Model: Schmidt 1		Date: 15-Mar-99	No.: 1
Modified Article: FCU		Prepared by: Y. Okunishi	
From: GTSS Field Information Dept			
Reason for Modification:	<input type="checkbox"/> Parts catalog correction <input type="checkbox"/> To facilitate assembly <input type="checkbox"/> Part standardization	<input type="checkbox"/> Vendor change <input checked="" type="checkbox"/> To improve reliability <input type="checkbox"/> Other	<input type="checkbox"/> To meet standards ()

Model: Schmidt 1 (FAX2000L)	Date: 15-Mar-99	No.: 2a
-----------------------------	-----------------	---------

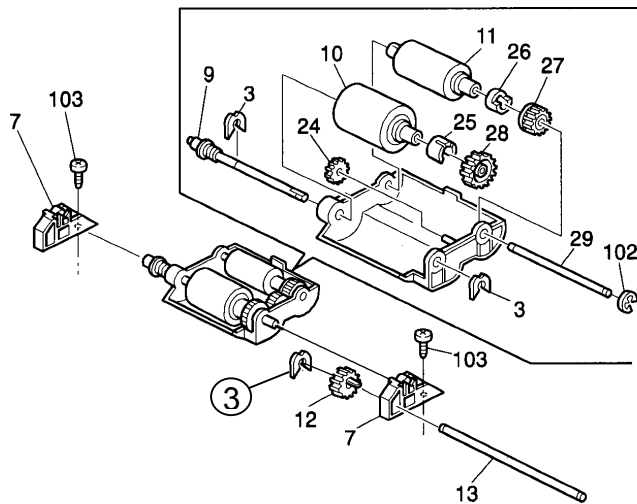
Model: Schmidt Series		Date: 19-Dec-01	No.: MH545023
Modified Article: ADF Feed Roller Collar		Prepared by: K.Moriizumi	
From: Technical Service Dept., GTS Division			
Reason for Modification:	<input type="checkbox"/> Parts catalog correction	<input type="checkbox"/> Vendor change	<input type="checkbox"/> To meet standards ()
	<input checked="" type="checkbox"/> To facilitate assembly	<input type="checkbox"/> To improve reliability	
	<input type="checkbox"/> Part standardization	<input type="checkbox"/> Other

Old part number	New part number	Description	Q'ty	Int	Page	Index	Note
H5351040D	H5351040E	ADF Feeder Unit	1	O/O	9	8	
H5351556	H5351530	Feed Roller Collar	1	O/O	9	25

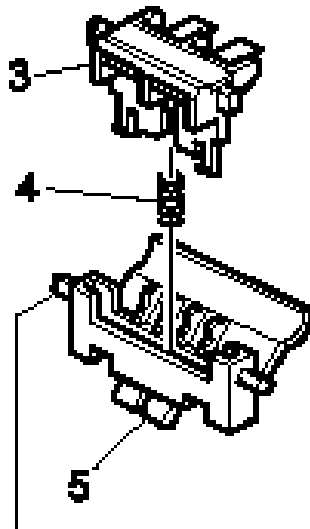
To ensure that paper jams and misfeeds do not occur at the paper entrance area, the Separation Pad has been changed, and a Separation Unit has been newly registered (consisting of the pad, holder, and spring).

Old part number	New part number	Description	Q'ty	Int	Page	Index	Note
H5453155	H5463111	Separation Pad - SS	1-1	O/O	23	3	
	H5463101	Separation Unit - SS			23	23

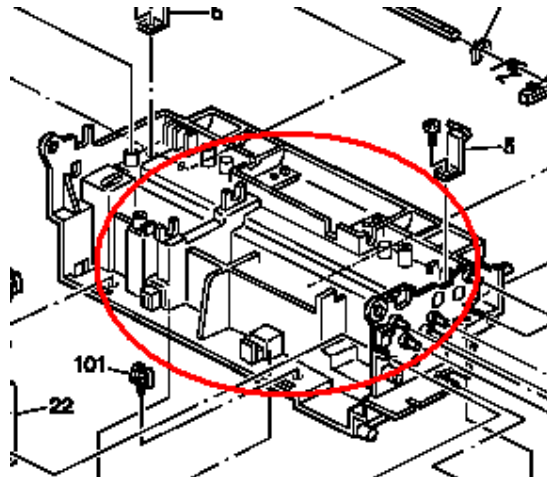
The Scanner Base has been registered as a Service Part.

Old part number	New part number	Description	Q'ty	Int	Page	Index	Note
-	H5451100	Scanner Base	1	-	11	-

Old part number	New part number	Description	Q'ty	Int	Page	Index	Note
-	H5351100	Scanner Base	1	-	11	-
